03346 Version 2

Product Update: 2006 Ridgeline Inner Door Handle Cable End Clip**(Supersedes 06-012, dated March 21, 2006; See REVISION SUMMARY)****AFFECTED VEHICLES**

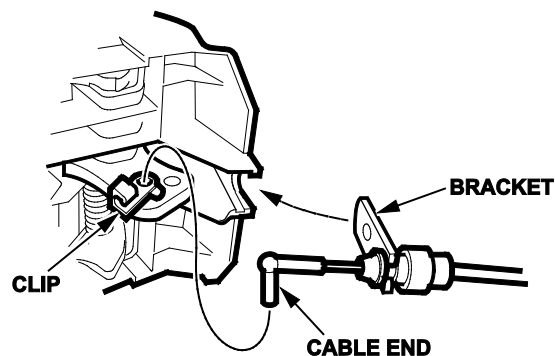
1. Remove the inner door handle. Refer to the service information.
2. Remove the cable bracket screw and detach the inner handle cable from the inner handle (right rear inner handle is shown).

3. Separate the cable end from the clip (snap).

4. Install the cable end into the new handle and secure the clip to the cable end.
5. Reinstall all parts in reverse order of removal.
6. Repeat steps 1 through 5 for the remaining three doors.
